30 March 2022

218757

**RESPONSE TO REQUEST FOR ADDITIONAL INFORMATION
SSD-11429726 – EDEN STREET COMMUNITIES PLUS**

Figure 2 Existing surrounding built context

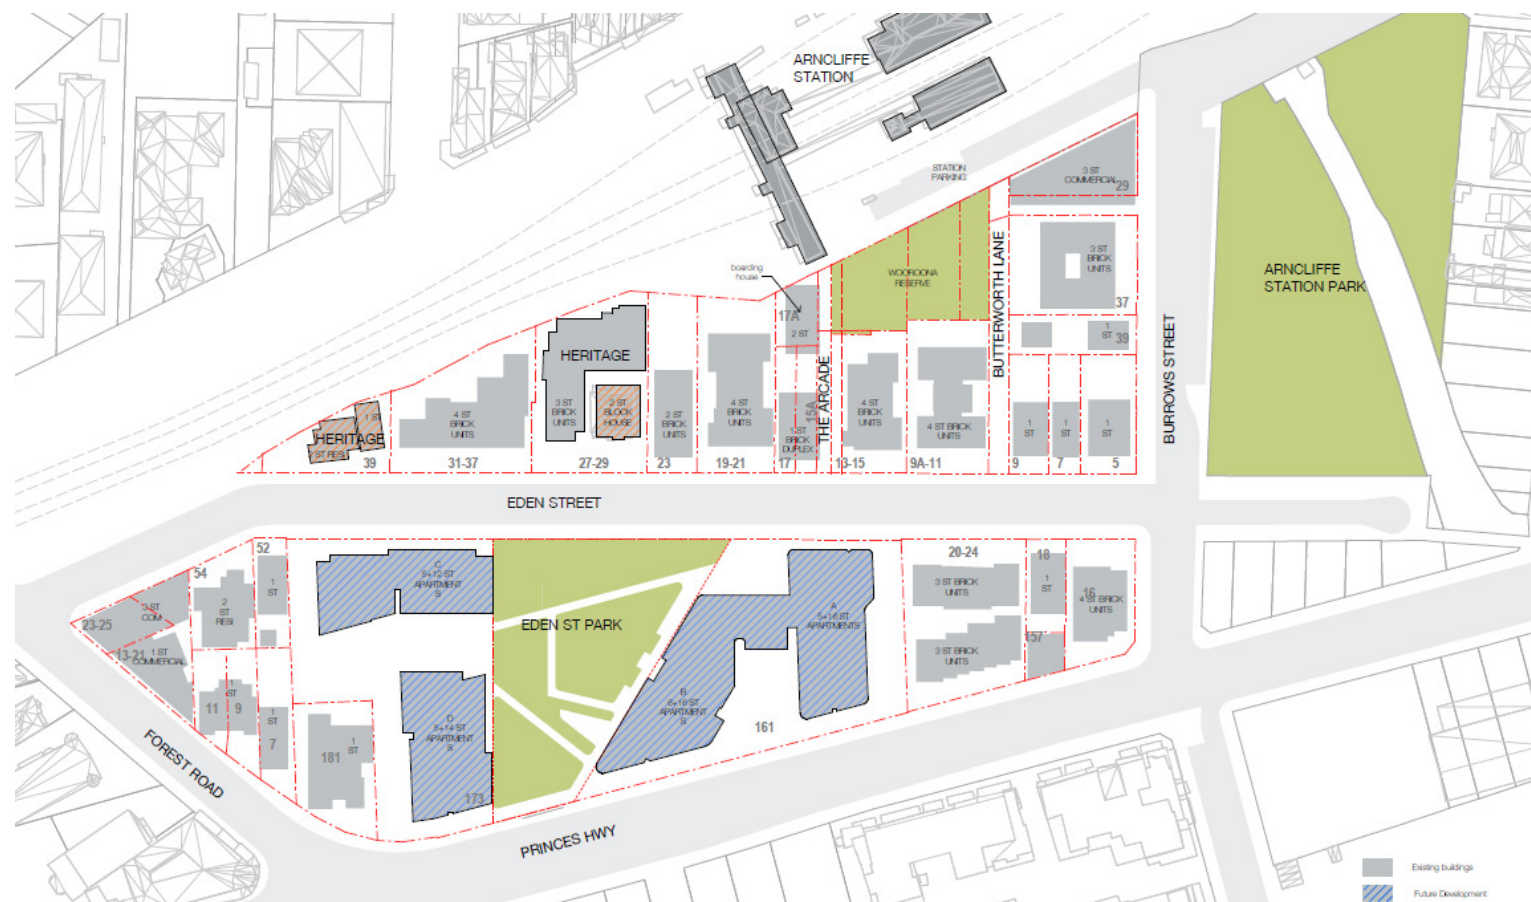
The proponent has undertaken substantive analysis of surrounding sites to ensure that the proposed development does not prevent them from being feasibly redeveloped in accordance with the ADG, including with regards to solar access.

The footprint of the surrounding built form is shown in **Figure 2** below.

Figure 3 Proposed Building Footprints

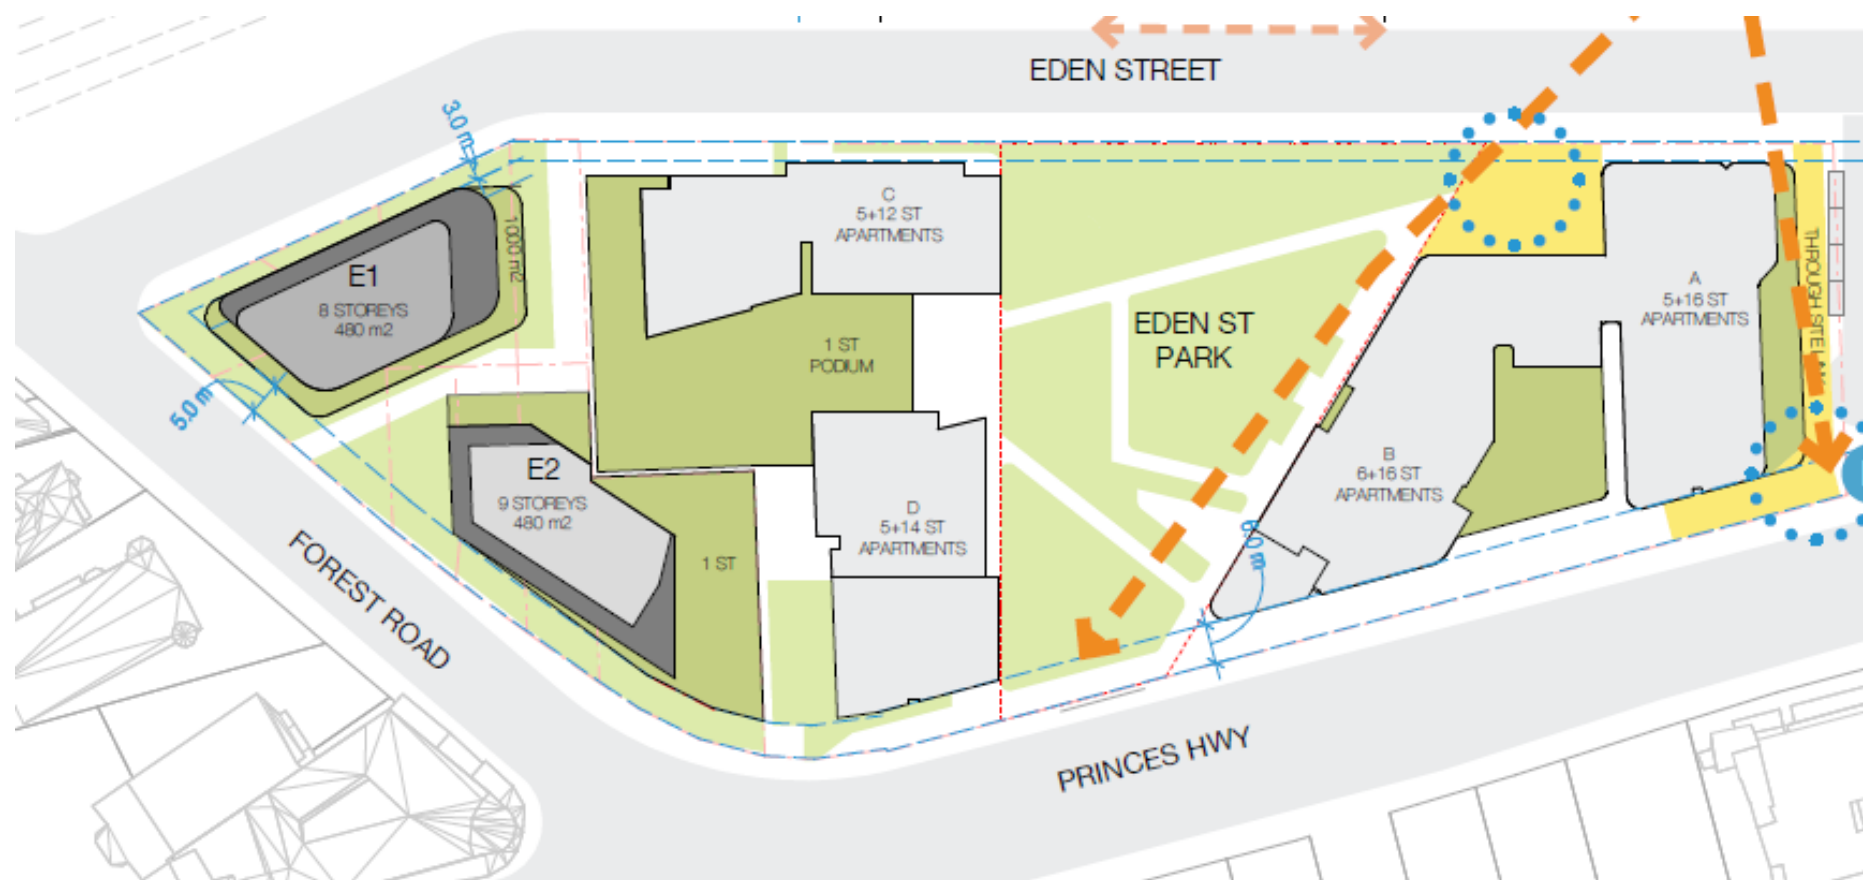
Group GSA derived a feasible redevelopment scenario in accordance with existing LEP height limits, feasible floorplates, as well as ADG parameters of deep soil and solar access. Refer to **Figure 3** below.

Figure 7 Sun Eye Diagrams – Block E2

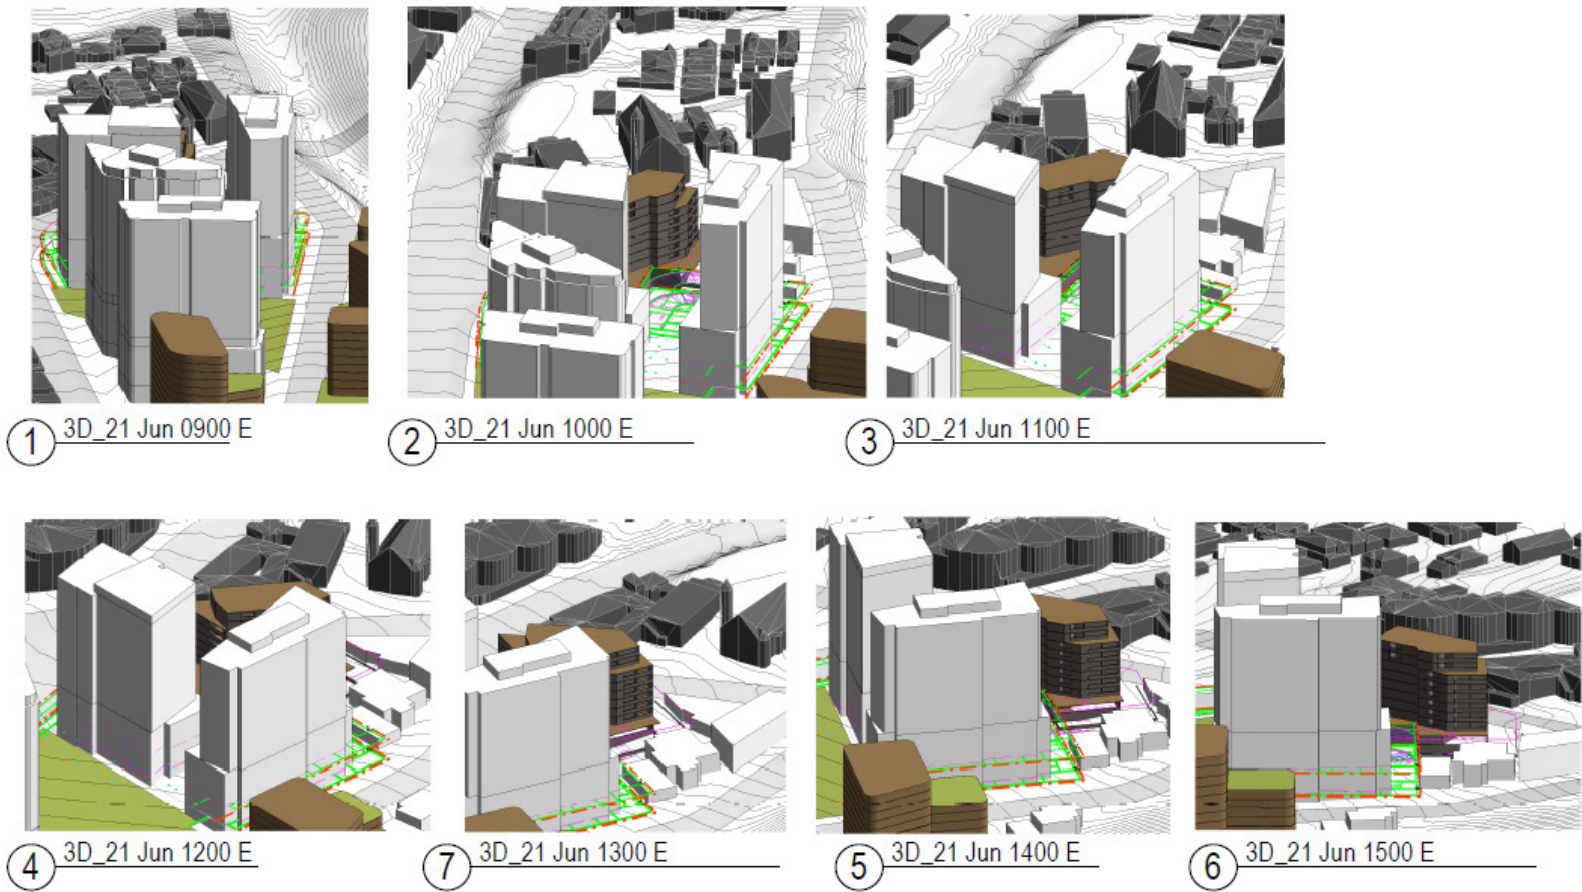
The sole exception are the two detached dwellings at 7 Forest Road and 181 Princes Highway, the latter of which is vacant and derelict. Notwithstanding this, the proposal has ensured that these two sites can be redeveloped (as part of a consolidated redevelopment that also includes 9-11 Forest Road – see **Figure 3** above) in a manner that meets ADG requirements for solar access and natural ventilation. The following figures illustrate how the indicative concept can achieve solar compliance in plan and through sun eye diagrams.

In the indicative development concept, 32 out of 46 apartments (70%) meet requirements for solar access, and 36 out of 46 (78%) meet requirements for cross ventilation. Therefore, surrounding sites can be redeveloped in accordance with ADG solar access requirements. See **Figures 4 – 7**.
